Proposed Contingency Authorization #

Collin County JJAEP Facility  
McKinney, TX

54

PCO #54- go with an 8' chainlink fence inlieu  
of the galvanized handrail previously approved as PCO #52

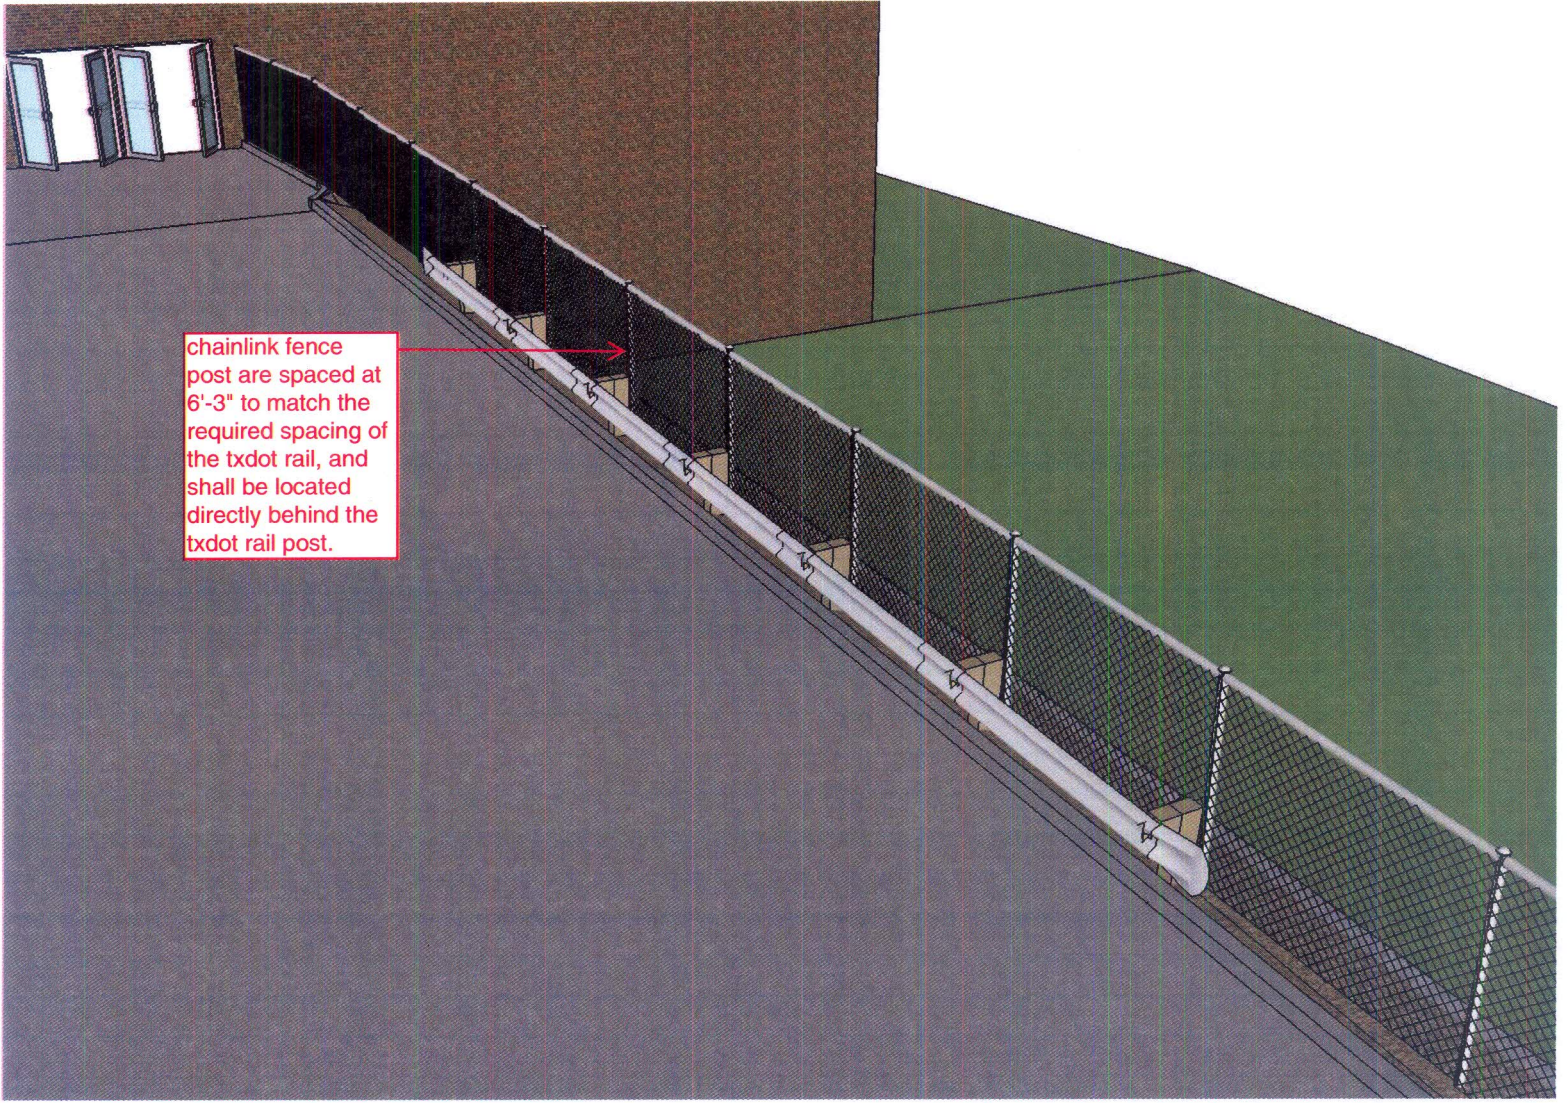
fence to turn back  
east behind the  
dumpster pad and  
stop at edge of  
retaining wall

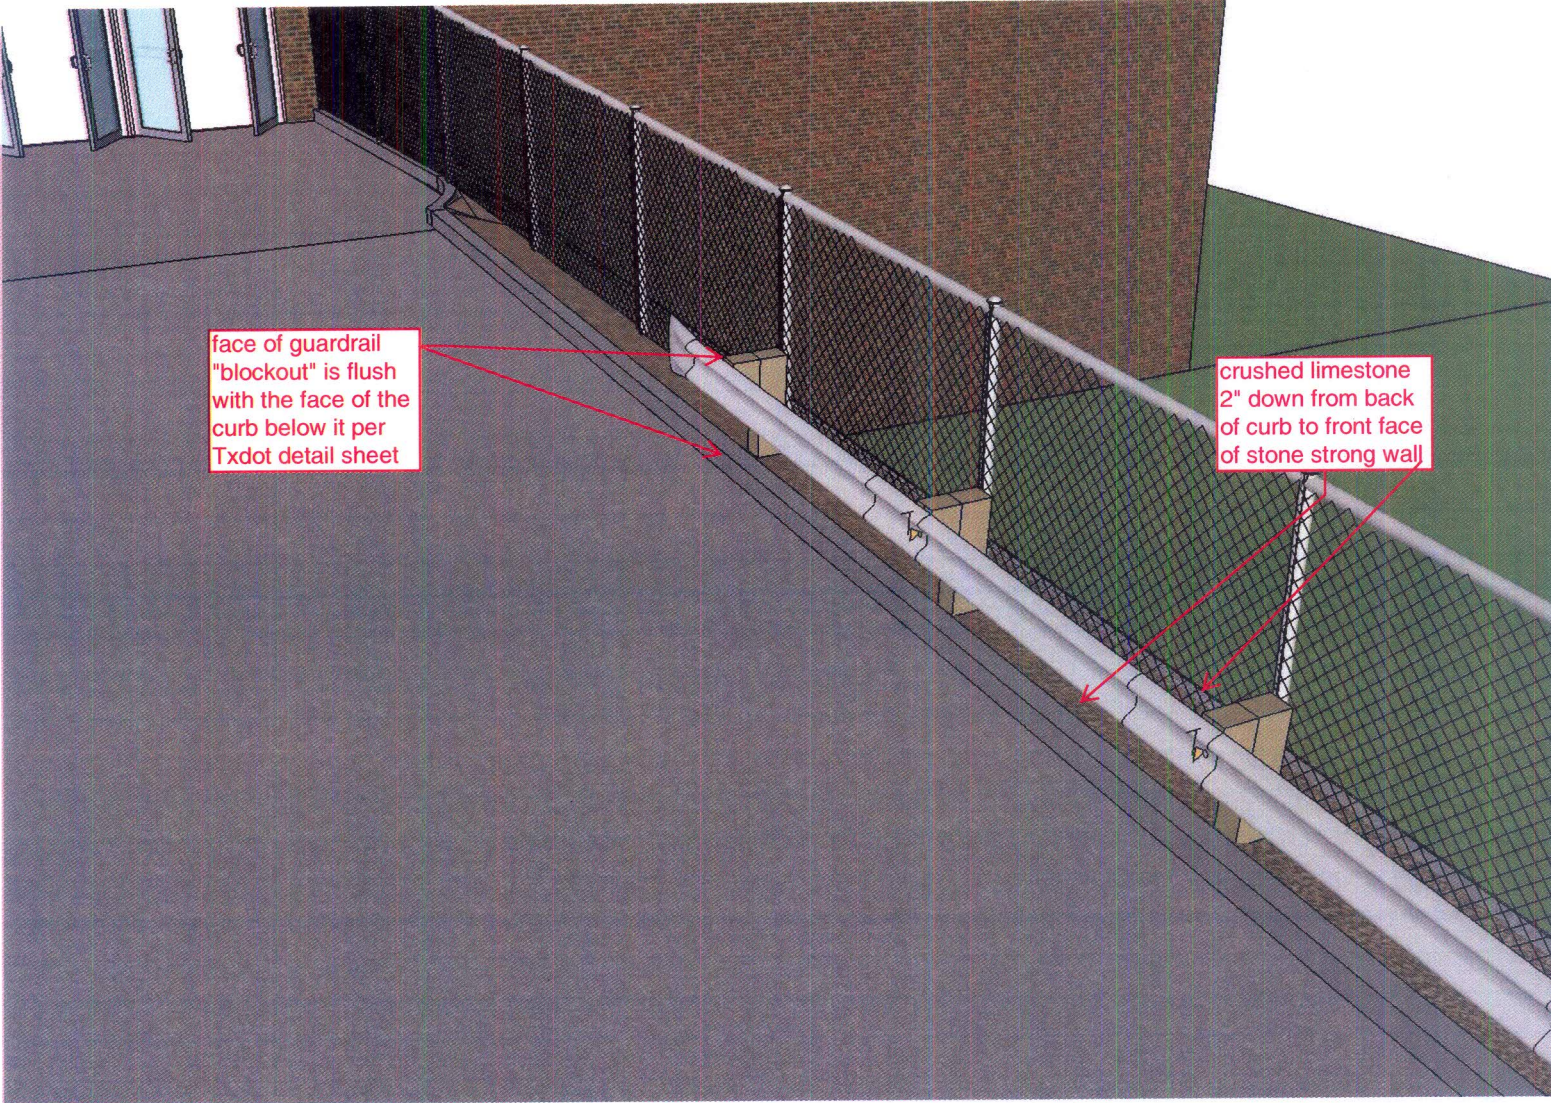
chainlink fence  
post are spaced at  
6'-3" to match the  
required spacing of  
the txdot rail, and  
shall be located  
directly behind the  
txdot rail post.

face of guardrail  
"blockout" is flush  
with the face of the  
curb below it per  
Txdot detail sheet

crushed limestone  
2" down from back  
of curb to front face  
of stone strong wall
